**WATER RESOURCES INTEGRATION PROGRAM (WRIP) PHASE 2,
PUMP STATION IMPROVEMENTS
SAWS Job No. 16-8604
SAWS Solicitation No. CO-00339**

**ADDENDUM 2
July 2, 2020**

E-1606

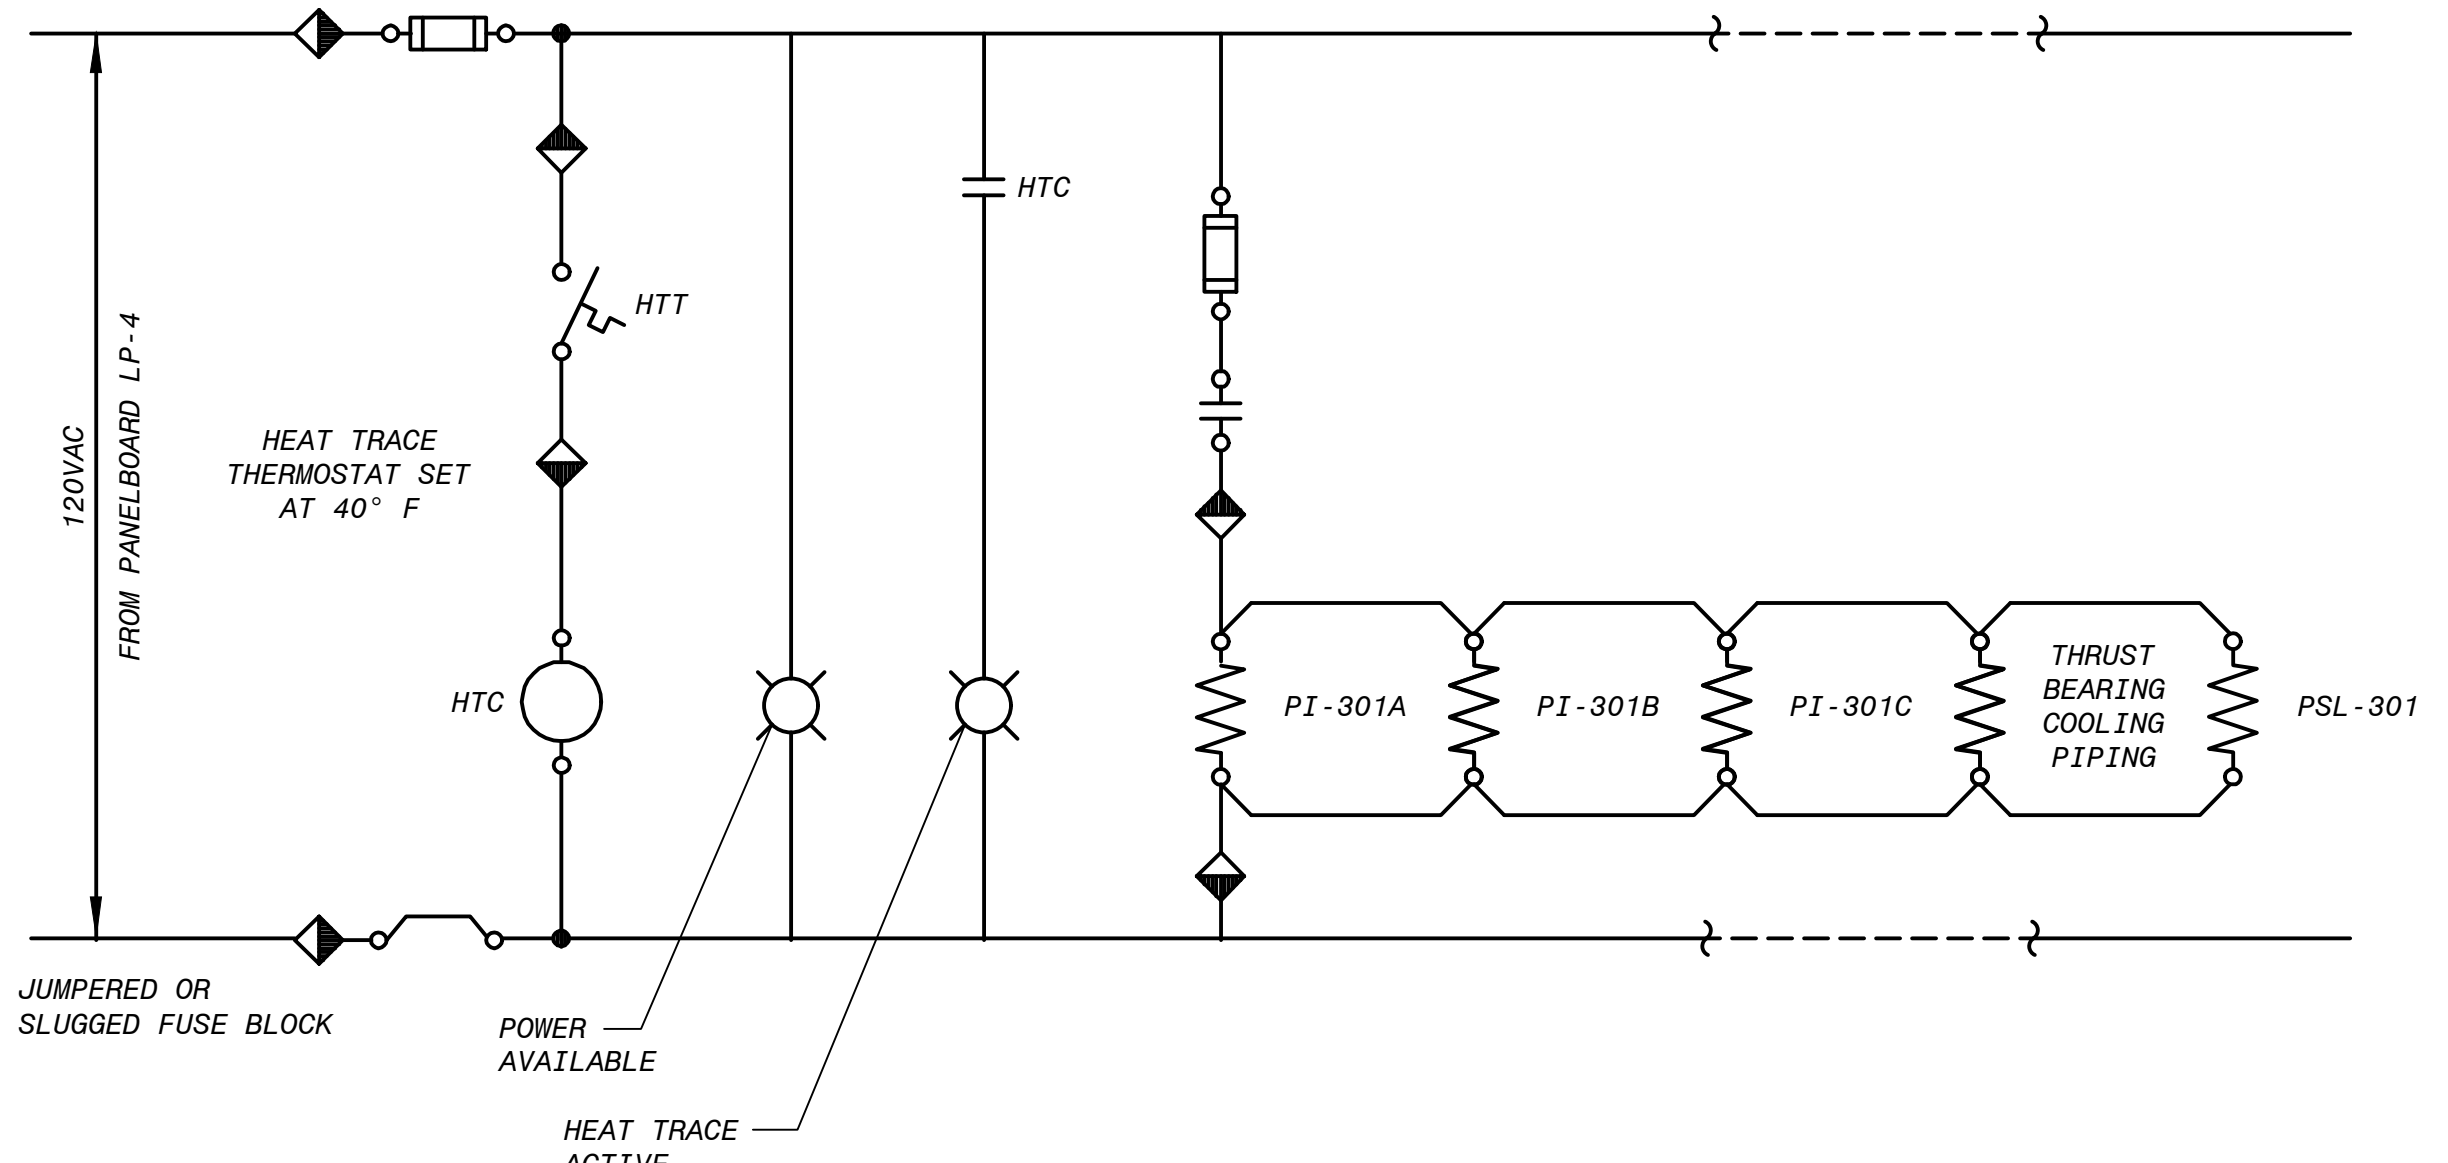
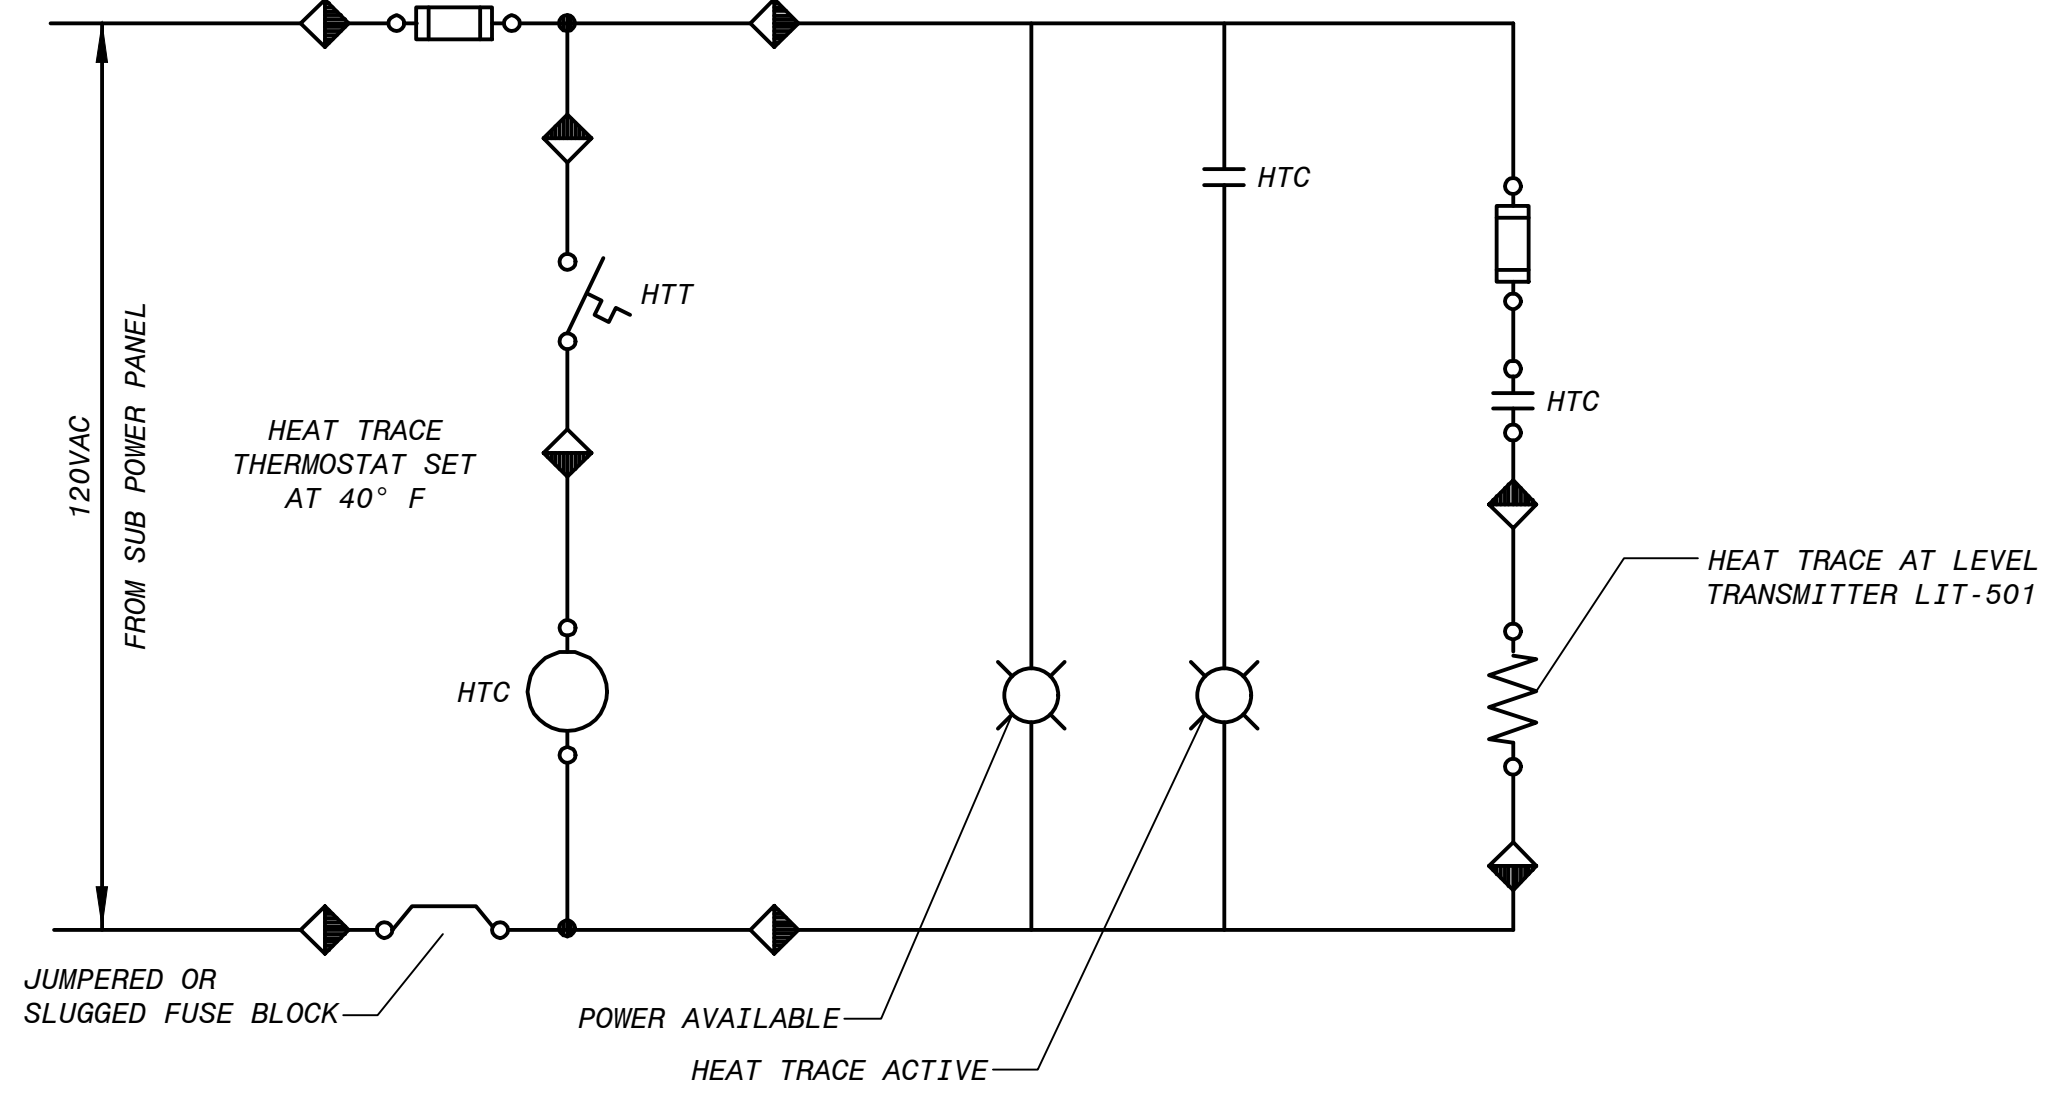
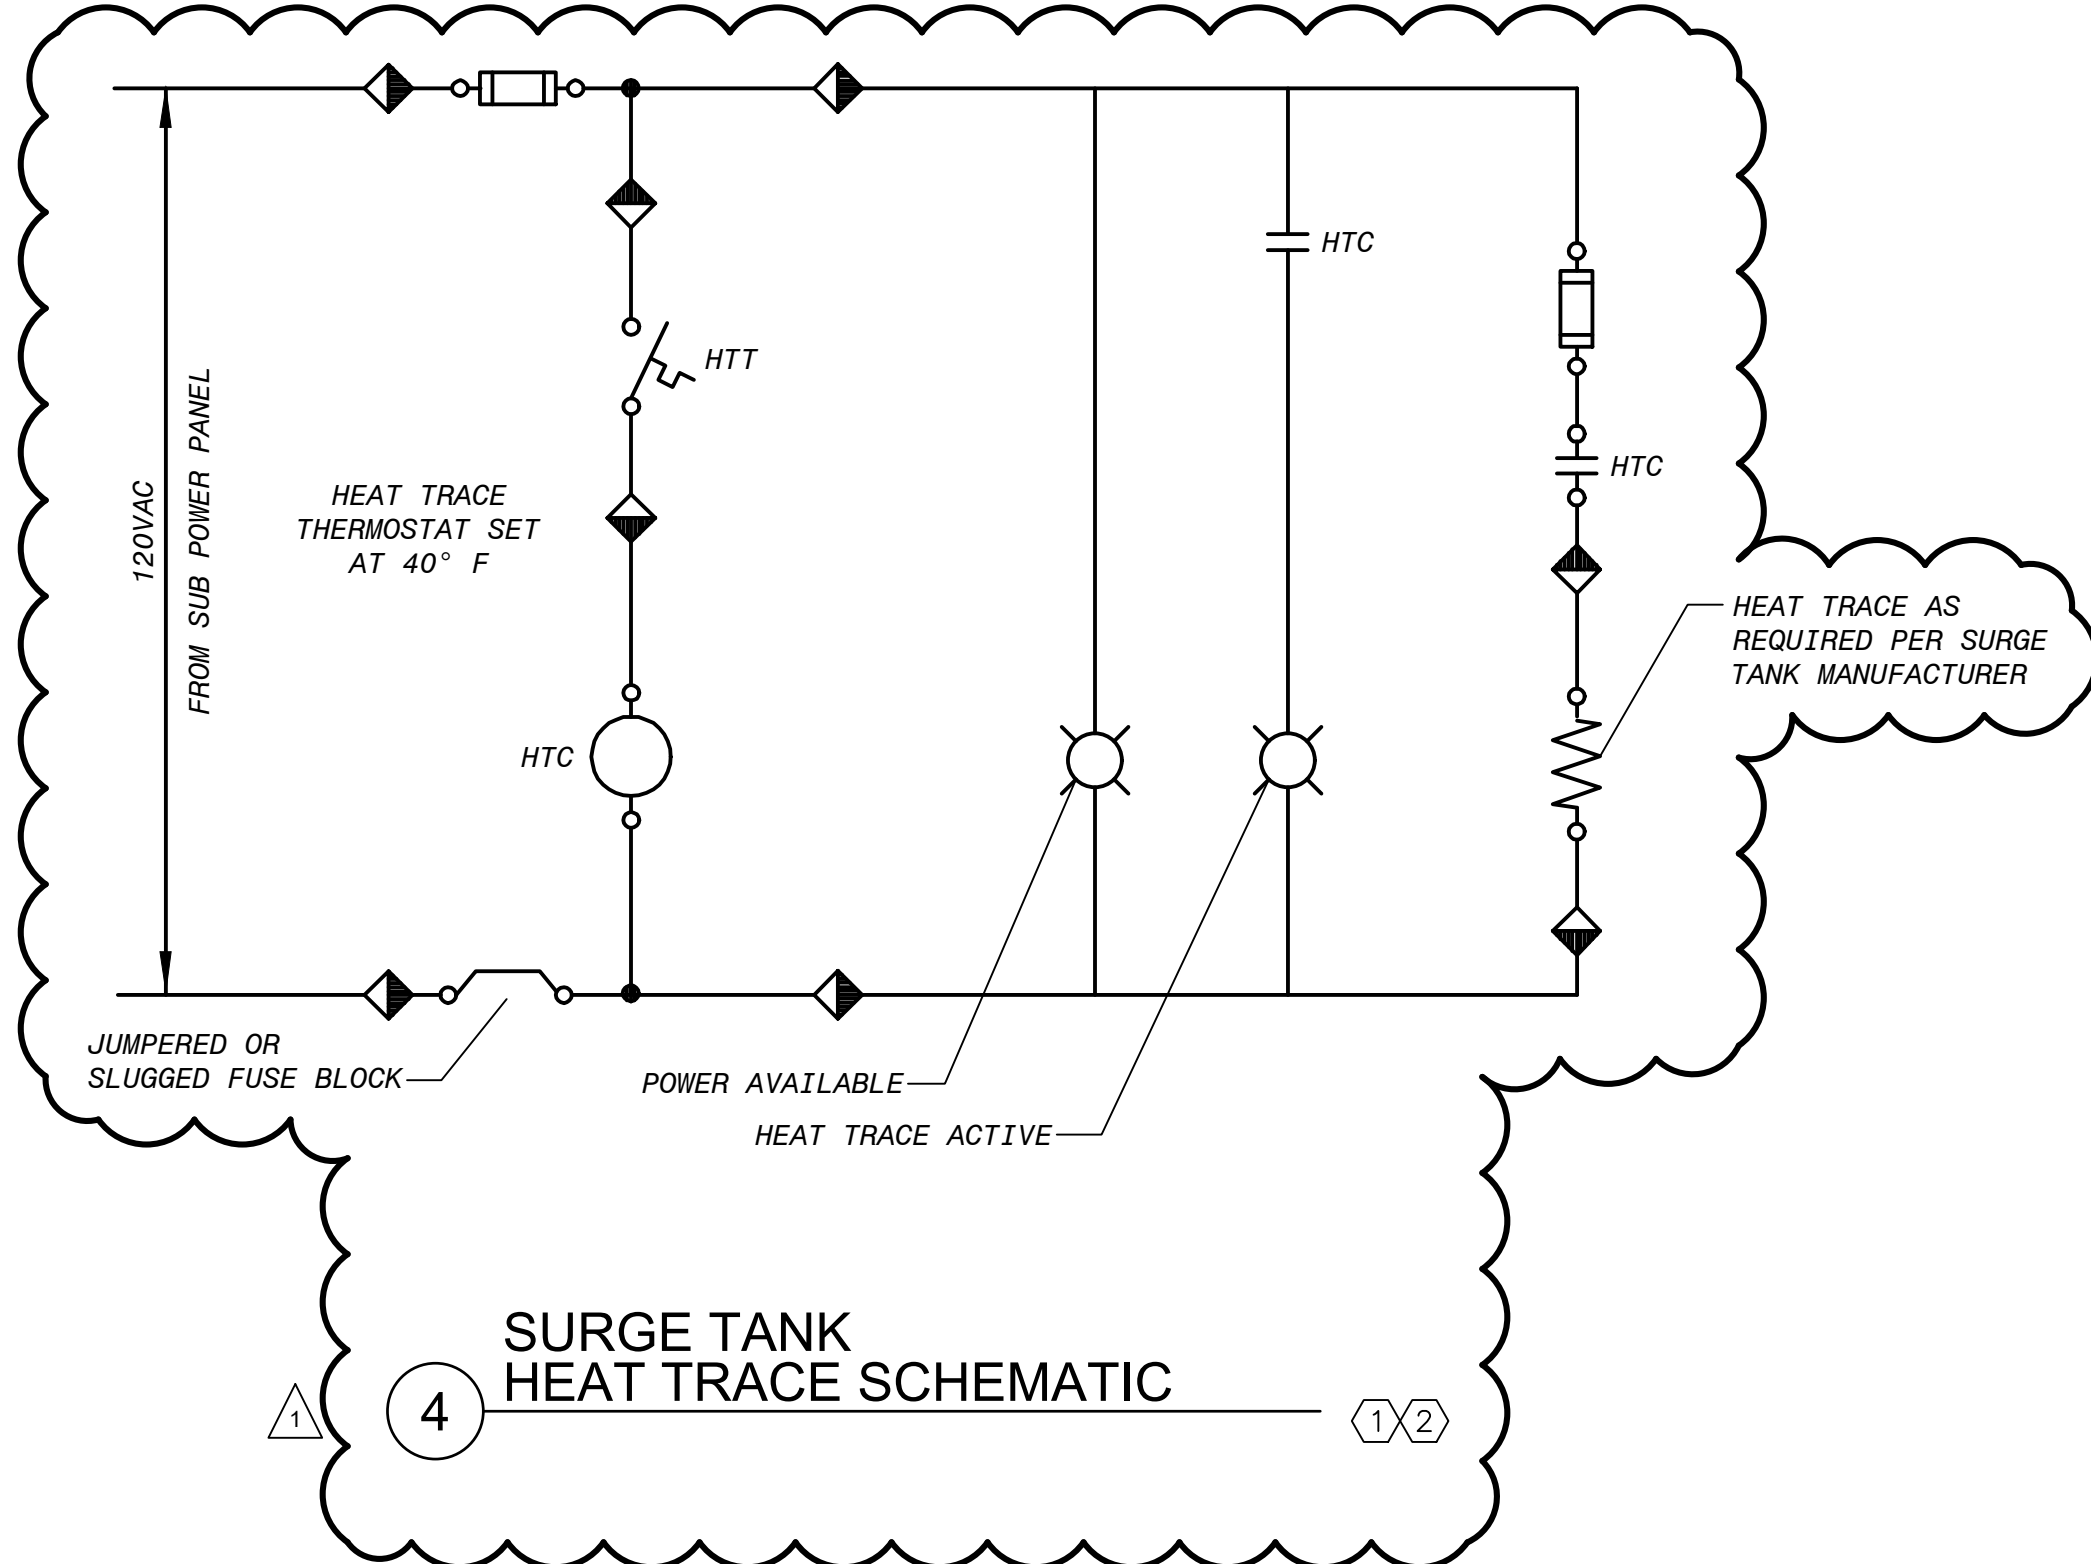
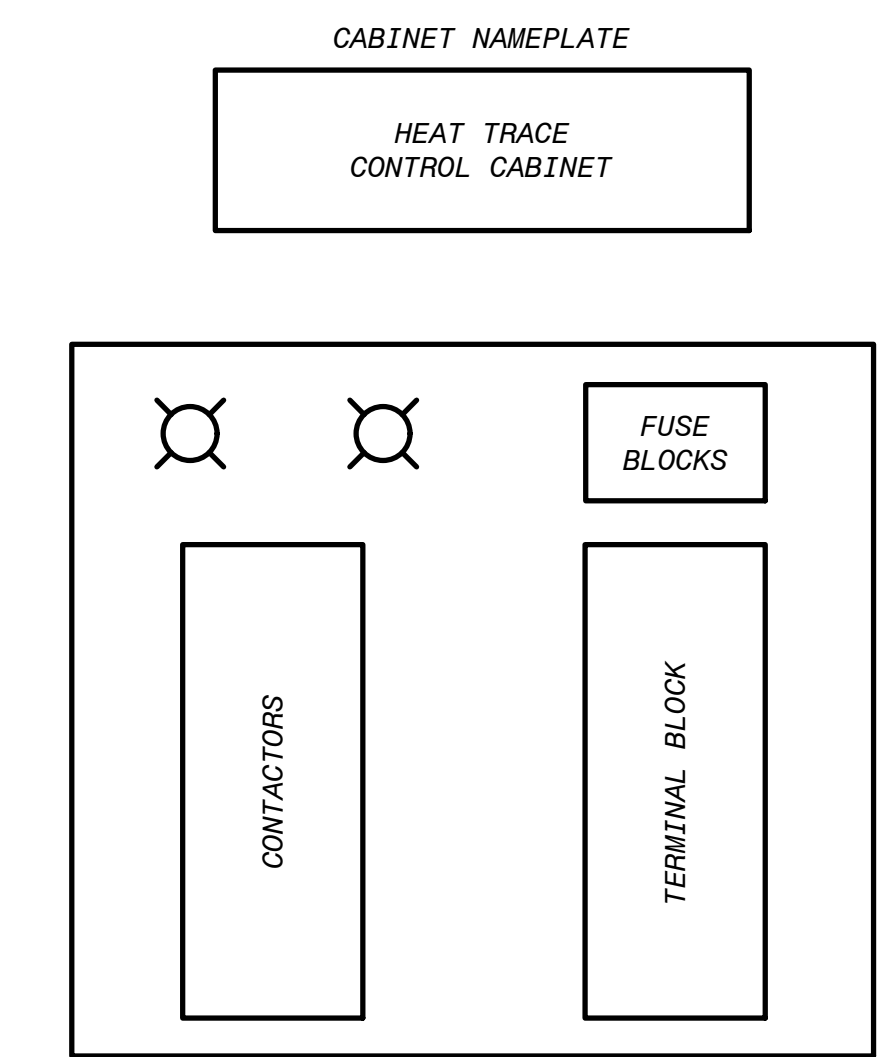
1. Replace sheet in its entirety with attached sheet E-1606, adding a Schematic 4 for the surge tank.
